DRAWING AMENDMENTS

NSD2003-006

APPLICATION NO. 10/670,540
 REPLY TO OFFICE ACTION OF MARCH 27, 2006
 REPLACEMENT SHEET

FIG. 1

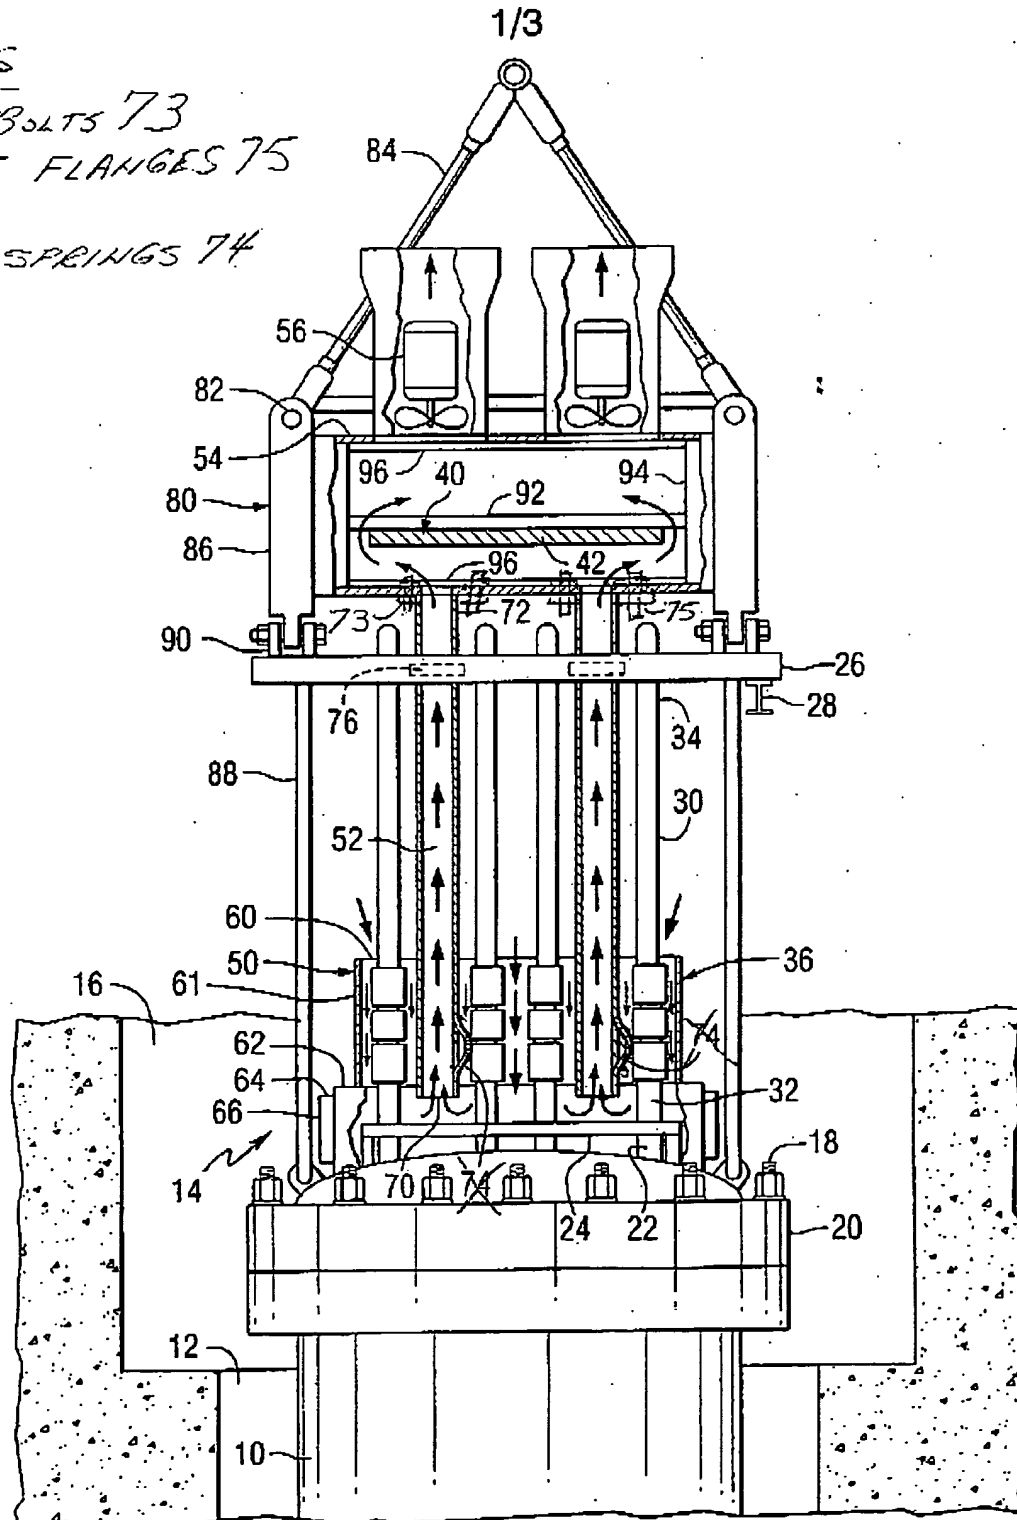
The Applicants note that the submitted version of Figures 1 and 4 incorporates two changes from the previously submitted version. The first change (to Figure 1 only) added bolts 73 and flanges 75 to the internal ducts 52. This structure is discussed in the specification at page 5, lines 14-17, and in the above Specification Amendments.

The second change is made (to both Figures 1 and 4) in response to the Examiner's suggestion at page 4, Paragraph 3(d) of the outstanding Office Action. Accordingly, Item No. 74 is deleted and the internal ducts 52 do not show a spring 74.

- ① ADDED BOLTS 73
 IN DUCT FLANGES 75
- ② DELETED SPRINGS 74

Figures 1 and 4 have been amended in accordance with the Examiner's suggestion of Subparagraph (d) to delete a reference to Item (74) and the depiction of a "resilient spring".

With regard to the phrase "the internal ducts are supported by the upper plenum" as it appears in Claim 6; the Applicant's have amended Claim 6 to recite that "the internal ducts are bolted to the upper plenum". This arrangement is discussed in the specification at page 5, lines 16-17. The specification and Figure 1 have been amended to conform to this change.
